**Docket Item #12 B-C**  
**Braddock Gateway – Phase II**  
**Development Special Use Permit #2012-0004**  
**Street Name Case #2012-0001**

DSUP #2012-0004  
Street Name #2012-0001  
Braddock Gateway CDD #15 - Phase II  
Landbays II & VI

**DSUP# 2012-0004**  
**SUB# 2012-0002**  
**CDD CONCEPT PLAN# 2012-0002**  
**STREET NAME CASE# 2012-0001**

Conceptual Park Design

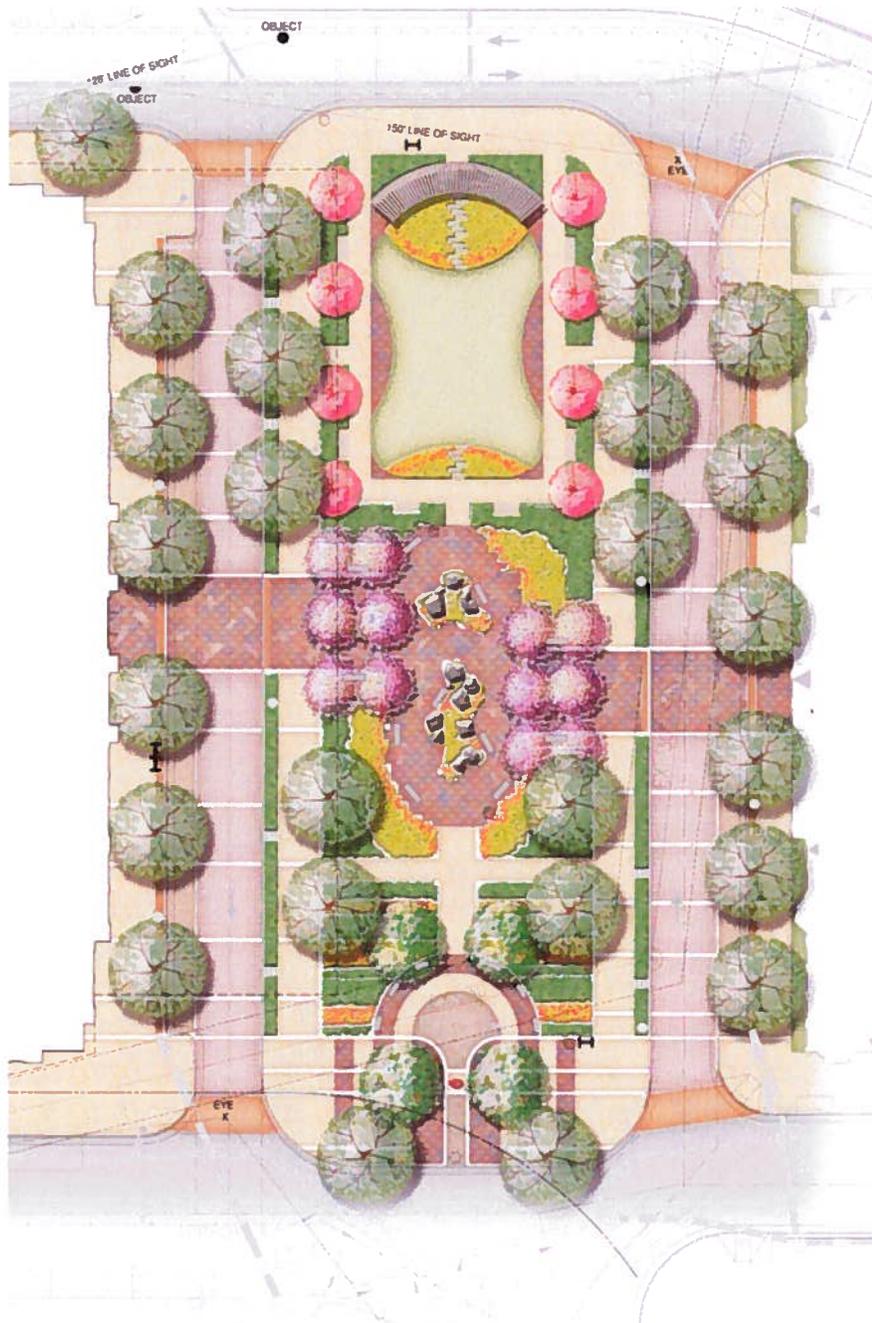
1. The Final Site Plan and building elevations shall be in substantial conformance with the preliminary plans dated April 16, 2012 and shall comply with the following conditions of approval. The design of the central park which will be finalized during the final site plan review.

**Emergency Vehicle Easements**

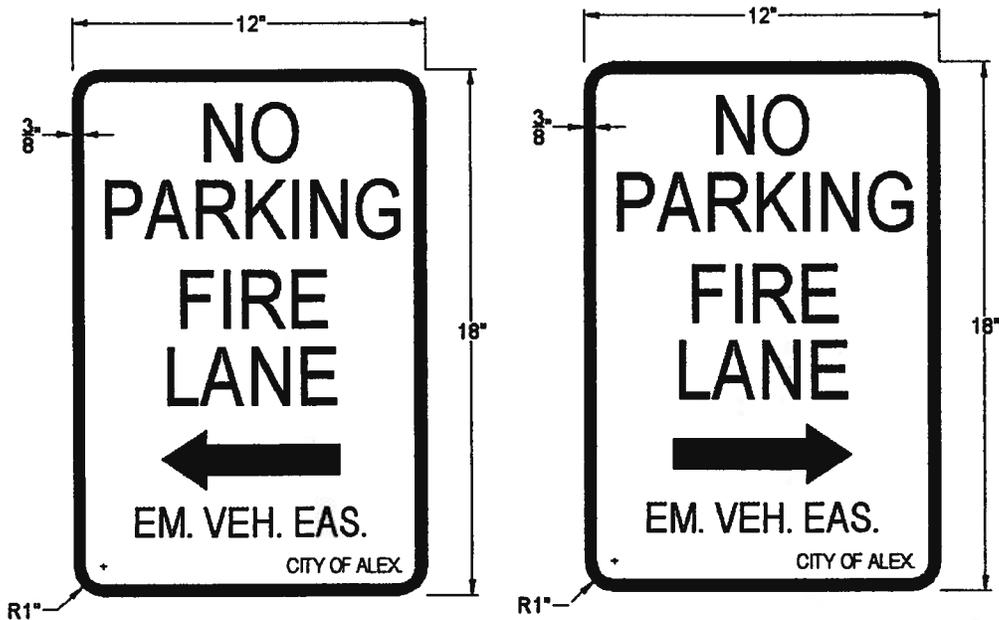
**In addition to the side type shown on page C12.00, the following sign types shall be installed. Please revise sign designation and locations so that fire lanes are clearly marked with directional signs.**
